Technical Service Bulletin 020710 IOX/DCX Thermistor Modification

INSTALLATION INSTRUCTIONS FOR RESISTOR TEMPERATURE SENSING UPGRADE

CIOX/DCX HPA

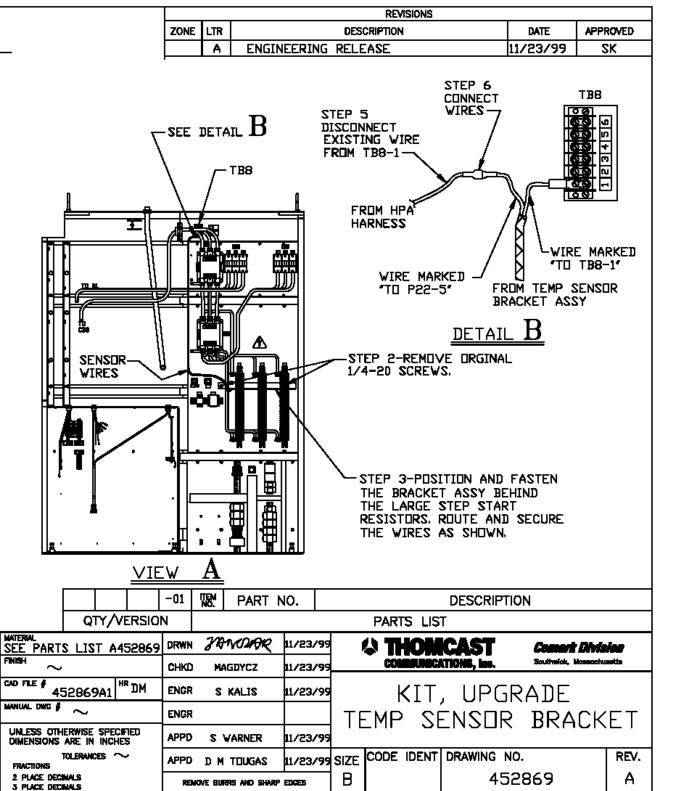
PURPOSE OF UPGRADE: INSTALLING THIS TEMPERATURE SENSOR BRACKET ASSEMBLY WILL PROVIDE AN EQUIPMENT PROTECTION INTERLOCK THAT WILL PREVENT THE DAMAGE OF CABINET COMPONENTS SHOULD THE RADIATED HEAT FROM THE 1000W STEP-START RESISTORS BECOME EXCESSIVE FOR ANY REASON, ONCE INSTALLED THIS PROTECTION INTERLOCK WILL BE IN THE SERIES LOOP THAT CONTAINS THE KEY SWITCH INTERLOCK OF THE GROUNDING SWITCH ASSEMBLY, THE HV COMPARTMENT DOOR SWITCH AND ANY EXTERNAL HVPS INTERLOCKS, ALL OF THESE PROTECTION INTERLOCKS TOGETHER FORM ONE LOOP CALLED THE "CABINET INTERLOCKS" AS SEEN ON THE FRONT PANEL OF THE HPA CONTROLLER IN THE "HPA START" SECTION OF STATUS LED'S, IF ANY ONE OF THESE SWITCH CONTACTS OPEN THE CABINET INTERLOCK WILL FAULT. THE HPA WILL THEN REVERT TO THE START MODE AND WILL WAIT FOR THE FAULT TO CLEAR,

- 1. TOTALLY POWER DOWN AND LOCKOUT THE AC POWER DISCONNECT TO THE HPA.
- 2. REMOVE THE 1/4-20 SCREWS AS INDICATED ON DRAWING. (SEE "STEP 2")
- 3. SLIDE THE BRACKET ASSEMBLY (452868-01) IN BEHIND RESISTORS R1, R2 AND R3 AND FASTEN IT TO THE CABINET WALL USING THE 1/4-20 X 3/4" HARDWARE (602899-01) PROVIDED IN THE KIT. (SEE "STEP 3")
- 4. ROUTE THE SENSOR WIRES AS INDICATED IN VIEW ${f A}$
- 5. REMOVE THE WIRE FROM TB8-1 AND CUT THE SPADE TERMINAL OFF. (SEE THE LOCATION OF TB8 IN VIEW f A) STRIP APPROXIMATELY 1/4' OF INSULATION FROM THE END OF THE WIRE.
- 6. CRIMP THE MALE PUSH-ON TERMINAL (605534-01) PROVIDED IN THE KIT ON TO THE WIRE REMOVED FROM TB8-1 IN STEP 5, AND CONNECT TO THE WIRE WITH THE FEMALE PUSH-ON TERMINAL FROM THE BRACKET ASSEMBLY MARKED "TO P22-5".
- 7. CONNECT THE WIRE FROM THE BRACKET ASSEMBLY MARKED "TO TB8-1", TO TB8-1,

- 8. USE THE TIE WRAPS (601268-01) PROVIDED IN THE KIT TO SECURE THE ROUTING OF THE WIRES.
- ONCE THE INSTALLATION IS COMPLETED AND EVERYTHING IS SECURED, POWER CAN BE REAPPLIED TO THE HPA.
- 10. SCHEMATIC 451186 AND 451206 SHOULD BE REPLACED IN THE HPA MANUAL DOCUMENTATION, SEE SECTION 14 AND 9 RESPECTIVELY.
